Section: 412-03

Model: Galaxy 2000.75, built up to and including 21.07.2002 (build code 2M)

Subject: Air conditioning system inoperative or inadequate cooling power; leaks in the air conditioning system

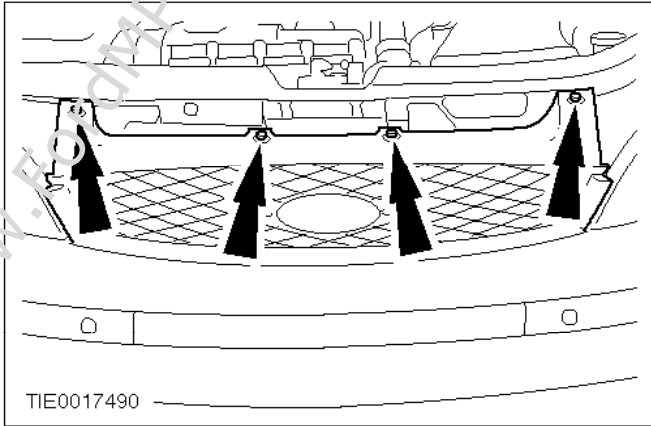
A revised air conditioning condenser has been installed in production since 22.07.2002 (build code 2M).

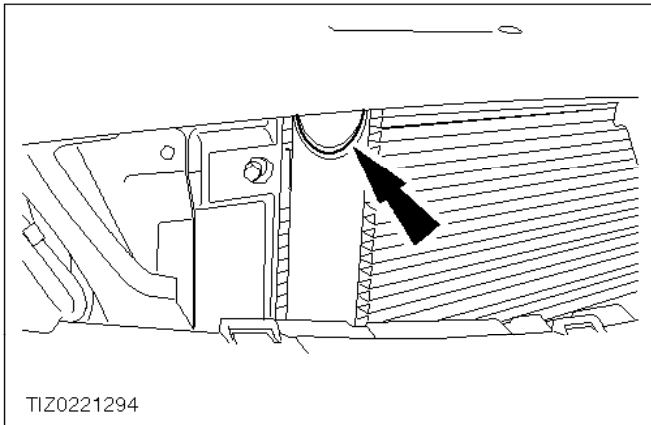
2. Detach the radiator grille from the grille opening reinforcement panel.
 - Remove the screws.

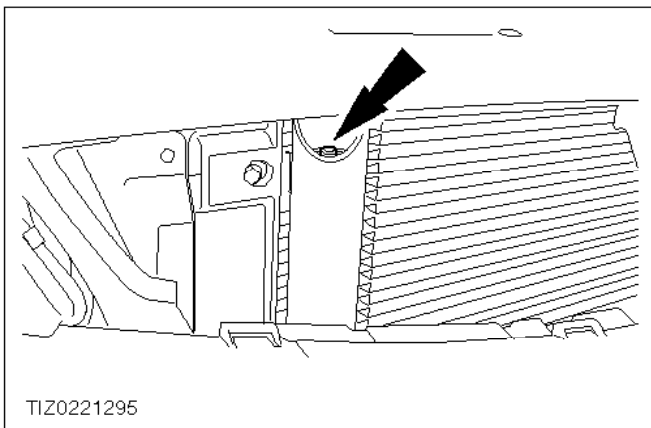
3. Detach the cover from the condenser.

4. Check the condenser for leaks.
 - Spray proprietary leak detecting spray into the opening and look for bubbles forming.
 - If bubbles are seen to form, install a new air conditioning condenser (see Parts Required).
For additional information, refer to 2000,75 Galaxy Workshop Manual Section 412-03A.
-
